Thanet Extension Offshore Wind Farm

Annex E to Appendix 28 to Deadline 6
Submission: Applicant's Response to Port of
London Authority and Estuary Services Ltd
Consultation Response

Date: May 2019

Gate Alignments

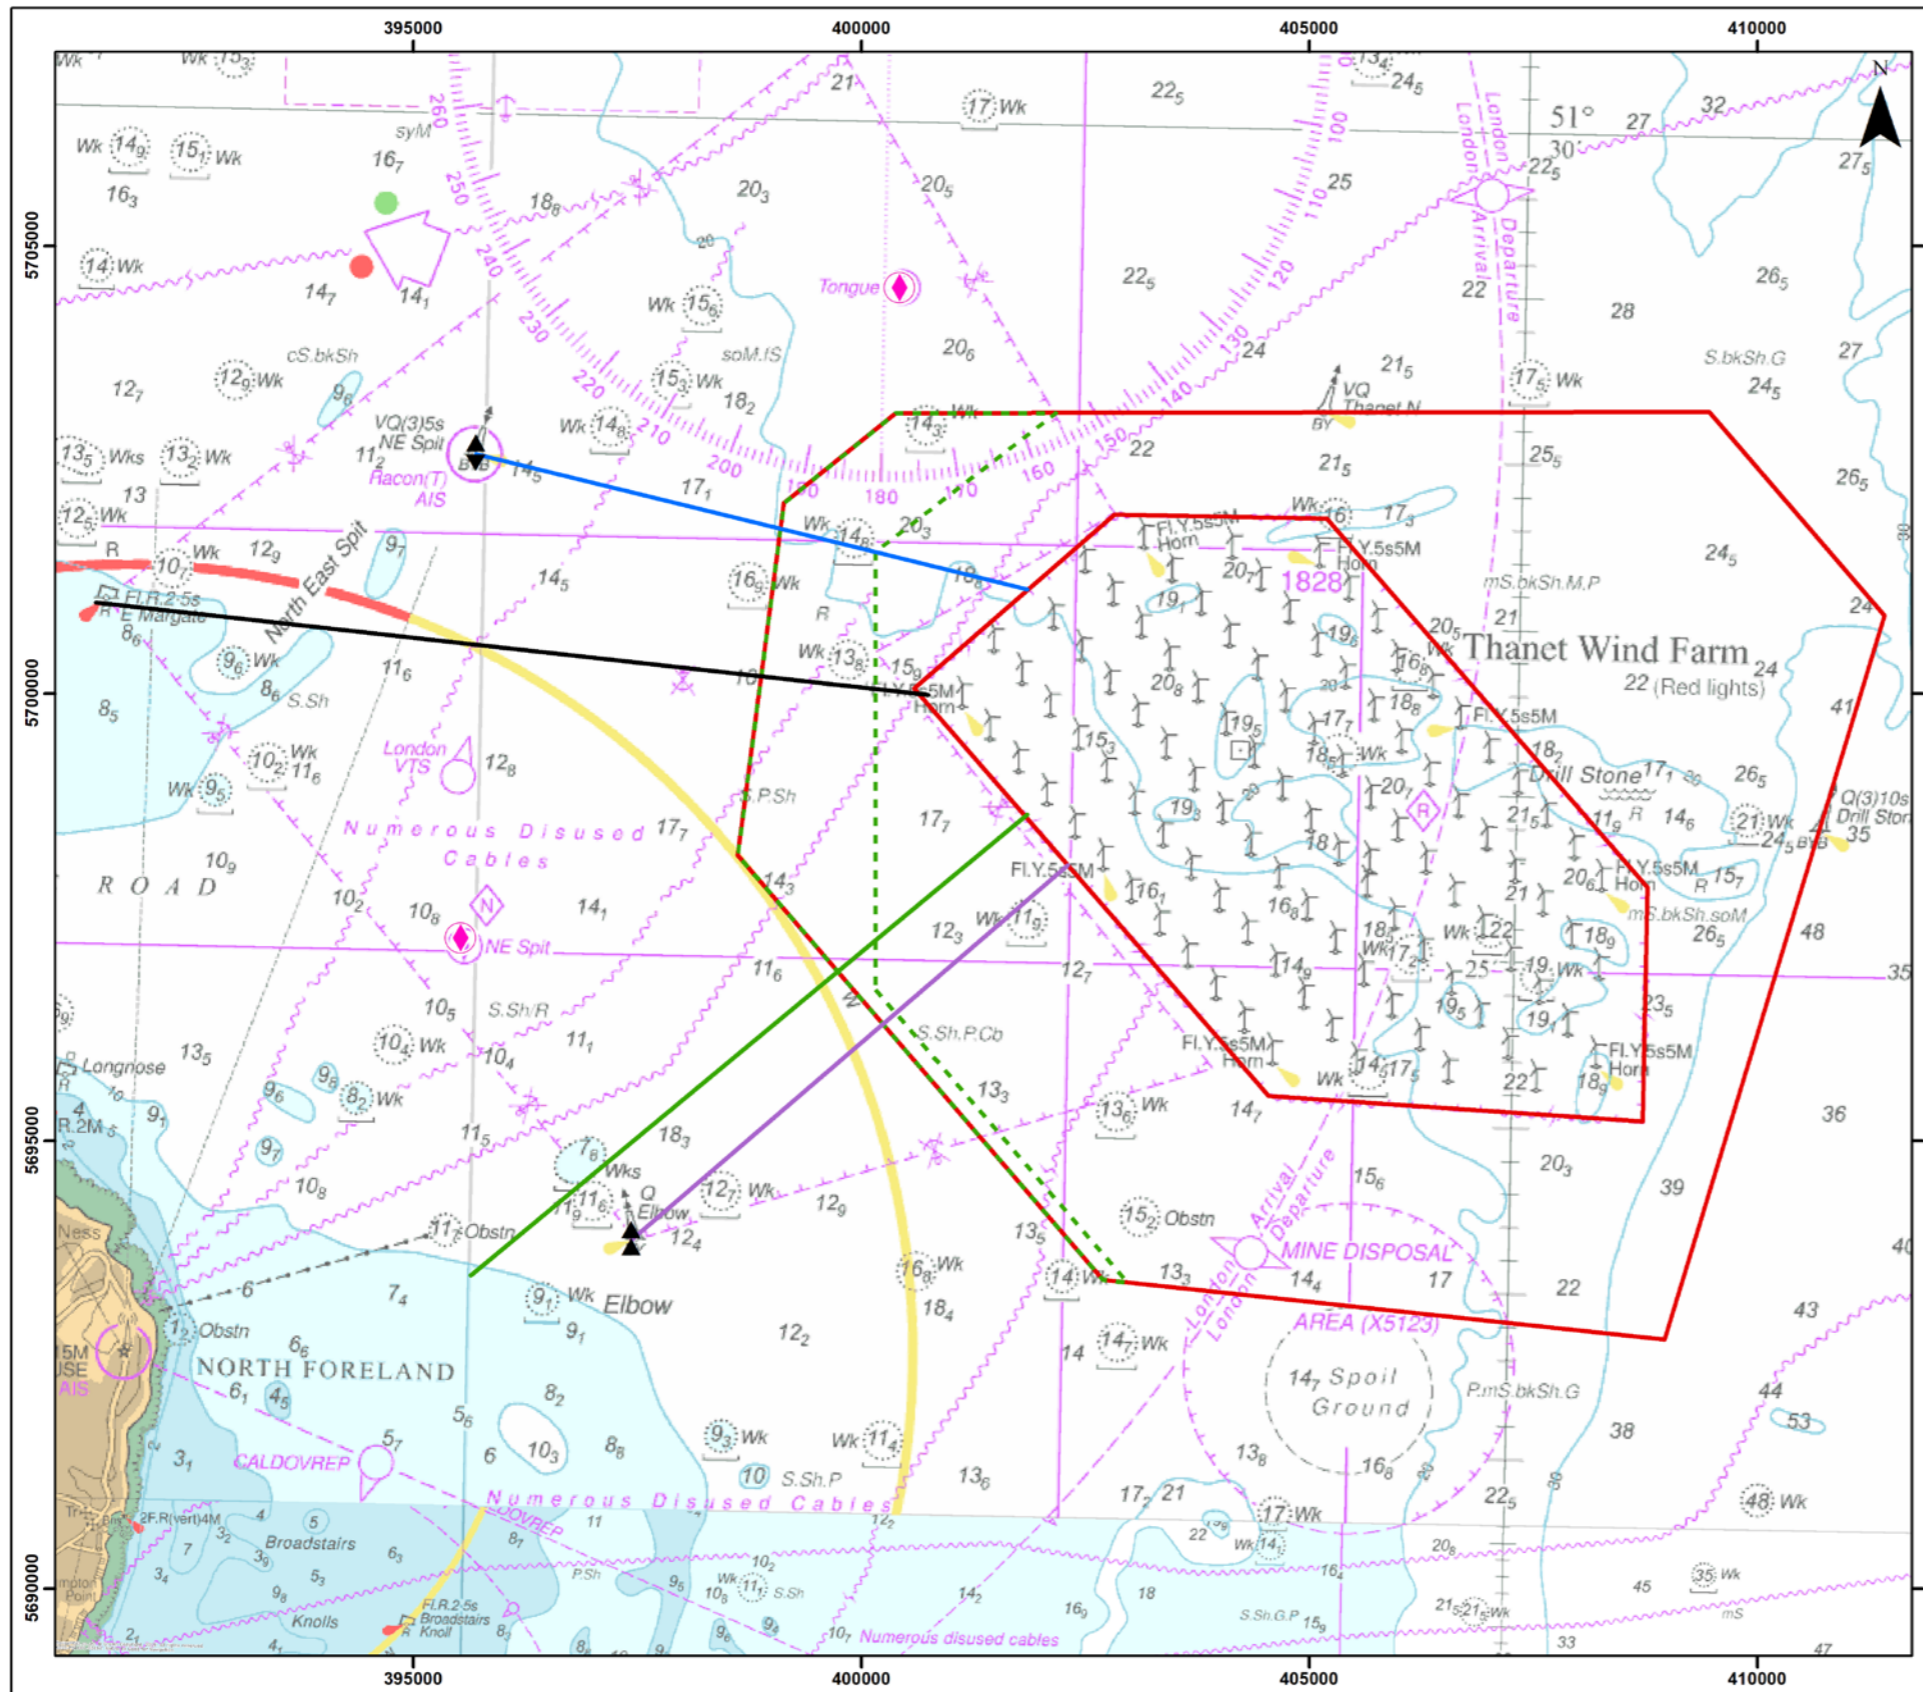
Section 7, para 54	Sea room between Elbow Buoy and SEZ	<p>The sea room in between Elbow Buoy and the SEZ is still a navigationally complex area and the definition of 'least' complex is misleading. The Elbow buoy area is a vital part of ESL's area of operation that allows flexibility when trying to operate in adverse weather conditions as well as being incorporated into run planning during boarding and landing peak periods. It is important for the safety of navigation in adverse weather, and to enabling flexibility in the planning of operations during such conditions. 238 vessels were served by ESL in the area of the Elbow in 2018.</p> <p>One third of the boardings and landings in this area took place during or adjacent to periods when ESL was operating a restricted service and the Sunk pilot station was either off station or restricted. The remaining two thirds of</p>	<p>The context of the complexity statement in Para 54 is that the area between Elbow Buoy and the SEZ is the least complexity of the reference locations that were agreed with IPs at the workshop on 27-Feb-2019. It is noteworthy that the premise of 2nm of distance at this location has been accepted by LPC in ISH8 (and proposed it in their own submission). The Applicant further notes that the sea room widens out significantly to the immediate north and south of this reference location and does not consider that the SEZ prevents the comparatively low number of continued operations in the vicinity of this location.</p>

Para 73	“Due to the introduction of the SEZ north of the Elbow buoy, the restriction between it and the SEZ, where the majority of traffic is transiting through, is an isolated point between much wider sea room to the north and south. The line of sight for vessels entering the inshore route from the south has been vastly improved as a result of the SEZ meaning there is not the same ‘channelisation’ of this area of sea and it remains fully	<p>The Elbow is central to ESL’s boarding and landing activities in adverse weather conditions; the proposed extension of the wind farm will have a detrimental impact on ESL’s ability to provide pilotage operations in such conditions.</p> <p>Furthermore, although this area may remain open for vessels, the narrowing of the channel is likely to make it unattractive to larger vessels for transit boarding and landing. In the PLA and ESL’s experience, they would expect masters of larger ships, when faced with the narrower channel created by the proposed extension of the wind farm, to avoid the area rather than risk transiting through a channel that is narrower and busier than it is currently. The Elbow buoy area has significant operational value to ESL, as this area is fully incorporated into its working practices particularly during poor met ocean conditions. It can be, and has been, the case that this area is the only workable area sea room available.</p>	<p>The Applicant refers to the comments above in relation to the Elbow buoy and the sea room that exists in this location together with the submissions made at Appendix 26 of this Deadline 6 submission in relation to use of Elbow for weather and commercial drivers.</p> <p>The Applicant also considers that there is no evidence to support the statement ‘likely to make it unattractive to larger vessels’. The basis of the area provided has been accepted by LPC for the vessels agreed likely to utilise the area and notes that there are other much narrower and busier areas through the vessels onward transits in/out the estuary. The Applicant also does not agree that the area at Elbow (and immediately north and south of this reference location) is lost as an area suitable for transfers.</p>

Consultation document	Document reference	Response summary/extract	PLA/ESL comments	Applicant regard
			<p>vessels using the area of the Elbow would have done so as a result either of the MetOcean conditions, or due to traffic considerations. Operations which took place when the Sunk pilot station was off station or restricted almost certainly took place in the vicinity of the Elbow as a direct result of adverse sea conditions which restricted or prohibited ESL's service and the use of the Sunk pilot station. If the Elbow had not been available as the reserve option for pilotage services,</p> <p>it is likely that ESL would not have been able to offer pilotage services at these times. This would have caused significant disruption to these vessels, which included container ships for London Gateway and Port of Tilbury and tankers for Grays, Shell, Navigator, West Thurrock and Oikos oil terminals. It would also have had a knock-on impact to subsequent vessels due at these berths.</p> <p>If the proposed development goes ahead, the use of the Elbow will be restricted or inhibited, which will increase the times that pilotage services are unavailable and, in turn, decrease the commercial attractiveness of these ports and terminals. The effect of that would be to reduce the employment and economic opportunities offered by the pilotage services, ports and terminals.</p>	<p>The latter points on commercial impacts are already addressed in D5 IP responses (Annex A and C to Appendix 26 of Deadline 6)</p>
